SUBDIVISION REVIEW SHEET

CASE NO.: C8-2010-0030.0A

SUBDIVISION NAME: RESUBDIVISION OF LOT 10 & 11, BLOCK F, SUMMIT OAKS

C8-2010-0030.0A SHEET 1 OF 1

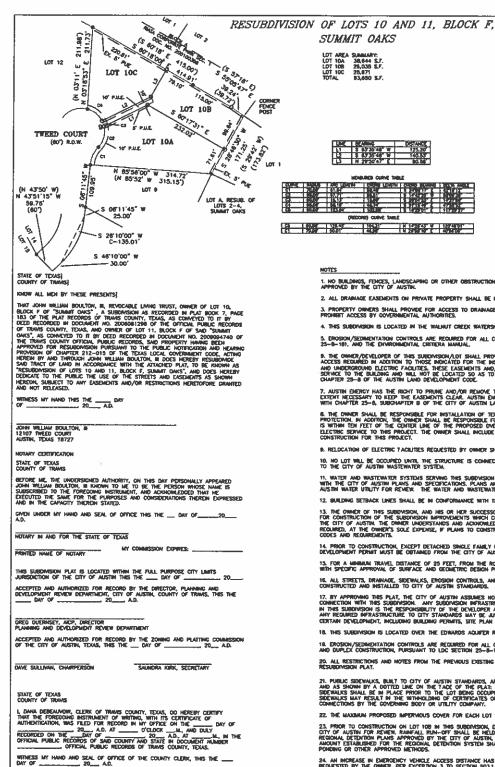
Staff has been contacted and has met with adjacent neighbor's regarding their concern for existing drainage problems in the area. Staff and the applicant's engineer has visited the site and based upon existing conditions have agreed to a diversion berm on Lot 10B, (1' X 100') to redirect increased stormwater runoff to the adjacent buffer to the northeast as a condition of RSMP approval.

Comments: THE ADDITIONOF ANOTHER HOUSE ONTO DUN STREAM COVER THAT WOULD CAUSE MORE FLOODIN TIONS (INSUAR ICIEN TROUTAGE) CHANGES THESE 2 LOTS VIOLATES DEED RESTRICT PARKING RITERTITION AND ADDS IMPERVIOUS SAC ALBERTY GINDERIGECIZE HERYT ADDS TRAPPIC TO A NARROW CULTUM-CHARACTER OF OUR NEIGHBOR TOO

comments: There are arrently already 250 these problems worse roject, I am concerned that teriel or meret will only make

Comments: My Cooperan is for shipty Daytime Telephone: <u>S 1&-&よくしるらい</u> the proposed Access to the axem stomorphic does not appear to allow too envergency DE DICTOR

STO SUNG Also - the designate is a concern - the water to Conond Rd and Affect severn

Length Dooblems. There Comments: Mr. Bolton worlds to put a house bakerd his existing house. The discred house would have tontage. There in violation of the deed rich stone 4000 S9 At John existing house which has caused horaster of our neighborhood. Mr. Enteradeel about sustin, TX 78767-8810 run of problems. The one the major reason who we objud one the major reasons built of nood frontage. The deed reconstrous house is to have atteast 100'
